BULLETIN No BE 03/96 MDM1-FOX

Enlarging the gap between the edges along the wing section contour , in the wing - fuselage connection .

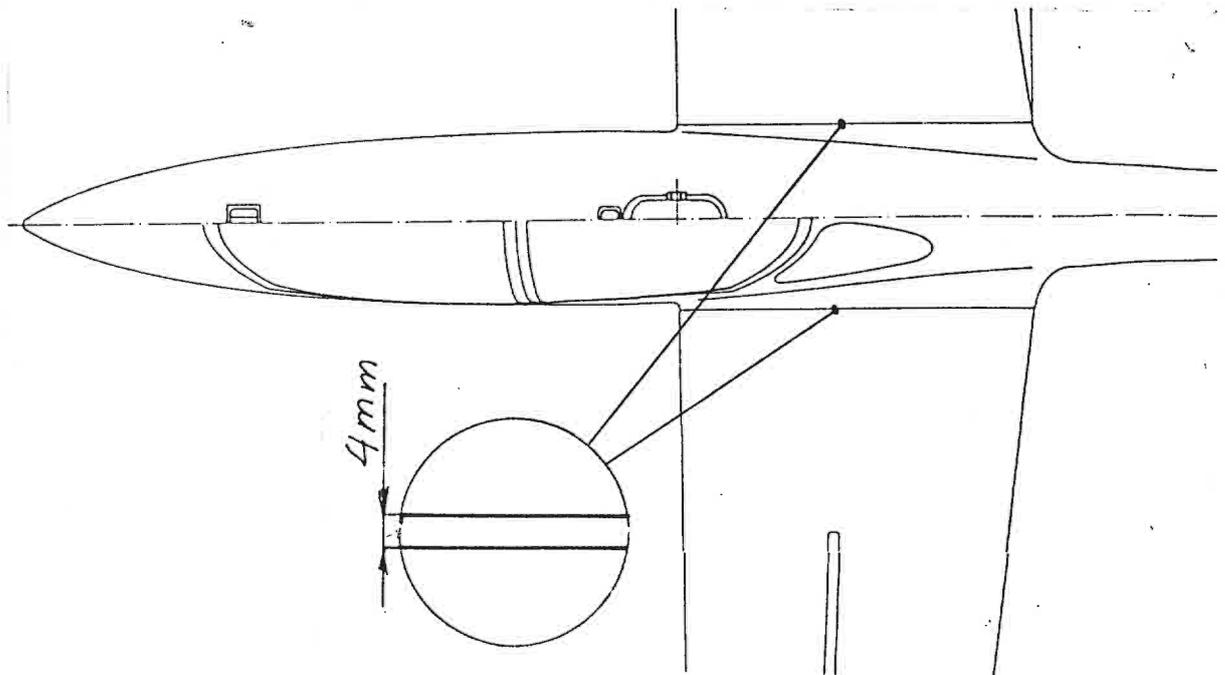
Basing on observations made both on gliders under operation and on the plane subjected to fatigue testing it has been found that the gap between the edges, in wing-fuselage connection, at maximum loads may be insufficient.

In some cases, the wing shell may touch the edge of fuselage, thus introducing additional stress.

It is recommended to enlarge the gap in wing-fuselage connection to approx. 4 [mm] over the whole wing section contour, on both wings.

On the rigged glider grind the edge of wing shell (on both wings) over the whole wing section contour, till obtaining in wing - fuselage connection the constant gap size of 4 [mm].

On the wing spar portion, cut out the shell with blade, with special attention paid to avoid incisions to spar fabric.

Protect the grinded edges by covering them with lacquer or resin composition.
